ADDENDUM # 1

RE: Spartanburg Community College – A Wing Renovation
Spartanburg, SC
OSE Project No. H59-6353-JM / CGD Project No. 26010

DATE: June 18, 2026

Jack A. Powers Building Floor Plan

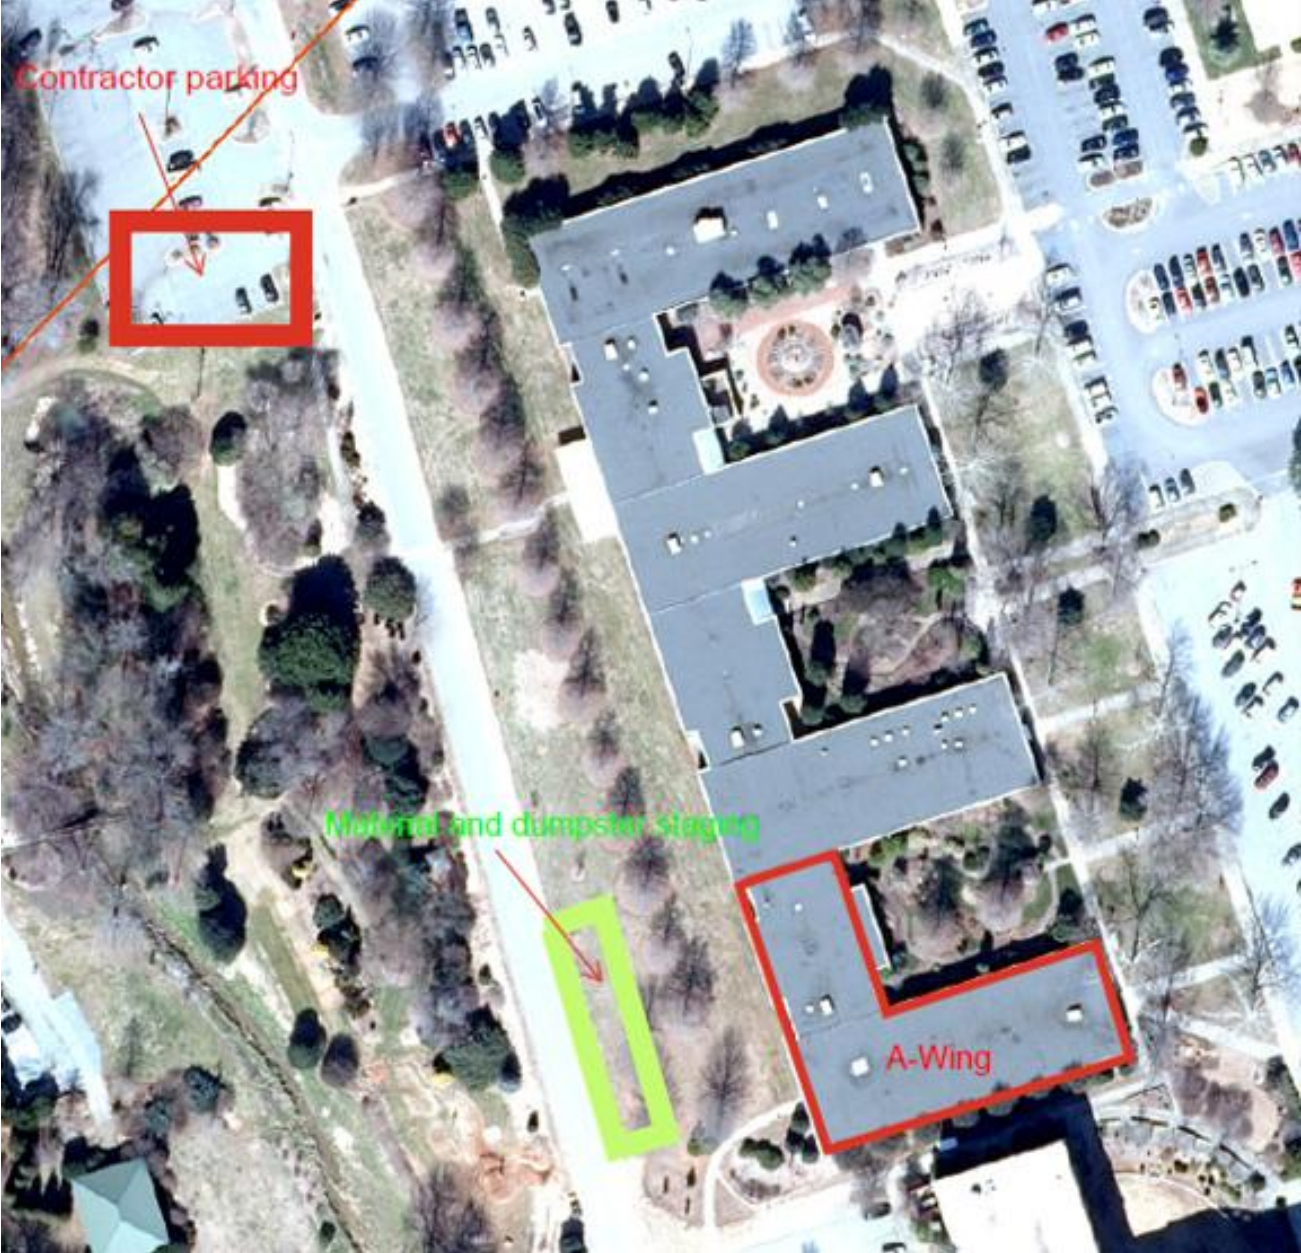
- G1 Clarification on contract insurance requirements:**
Insurance shall be provided as specified in the AIA-A101 Exhibit A SCOPE Version included in the project manual.
- G2 Clarification on laydown and staging areas:**
See attached Contractor Parking Diagram and Contractor Entrance Diagram illustrating proposed contractor parking, building entrance, and laydown/staging areas for the project.
